Access Compliance Report

Public Rights-of-Way

(Pedestrian Signals)

Intersection ID: N/A	Main Street:	Cross Street: N/A	Location: N/A
ADA ID: 85A2CA2ED24E	Signal Type: Two Push Buttons-APS	Overall Compliance: No	Severity Score: BTN 1:N/A BTN 2: N/A No BTN: N/A
Codes/Mitigation Info/Possible Solution		Field Measurements/Component Compliance

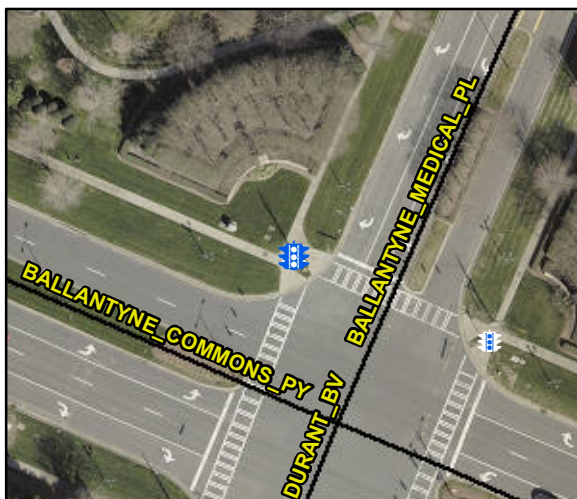
Yes B 1 Clear Xing Direction?	ClearlyMarked	Yes B 2 Clear Xing Direction?	ClearlyMarked
B 1 Crossing Direction	To SW	B 2 Crossing Direction	To SE
Yes B 1 DistanceTo XWalk (in)	0.0	Yes B 2 DistanceTo XWalk (in)	0.0
No B 1 DistanceTo Curb (in)	82.0	No B 2 DistanceTo Curb (in)	75.0
Yes B 1 Diameter (in)	2.0	Yes B 2 Diameter (in)	2.0

Possible Solutions: Replace Signal Push Button With APS Button on New Post. Remove & Relocate Sign.
